From: [Trevor Heywood](#)
To: [Clerk](#)
Subject: [External Sender] Infrastructure and Environment Committee Item IE31.1 - Options for Connecting the Loop Trail to The Meadoway
Date: July 9, 2026 8:34:47 PM
Attachments: [image.png](#)

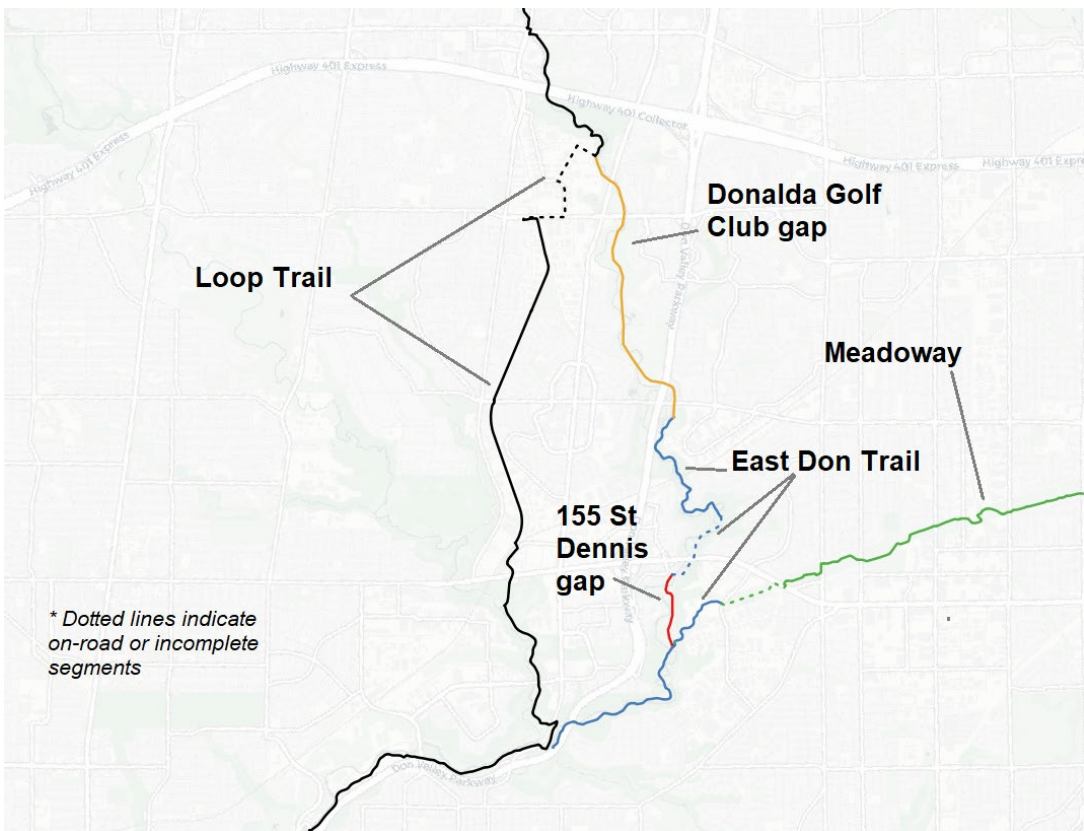
Such a northern connection is dependent on (please refer to the map below):

- "Phase 3" of the East Don Trail connection (dotted blue), partly through the current Flemingdon Park Golf Club and land subject to an Ontario Land Tribunal decision that the City chose to appeal to the Ontario Divisional Court (red). See City Council Items [2025.CC34.3](#) and [2026.CC41.14](#). I submitted correspondence on the former urging council to not pursue that appeal, and I'm still disappointed it is pursuing that case. It has further delayed this Phase 3 trail connection and now having spillover impacts on other trail initiatives such as this.
- A trail connection through the Donalda Golf and Country Club (yellow), which may be closer to reality with a land exchange between the City, TRCA and the owners. See City Council Item [2026.MM42.13](#).

I will also note this creates a more complete, off-road, ravine-based alternative to the Loop Trail's routing through Don Valley East, as opposed to using Duncan Mill Road / Valleybrook Drive / Lesmill Road / York Mills Road.

I would ask that the committee goes beyond receiving the report for information, and ask staff to further investigate a permanent trail connection through the East Don River valley between the Loop Trail (at Duncan Mill Road) and the Meadoway.
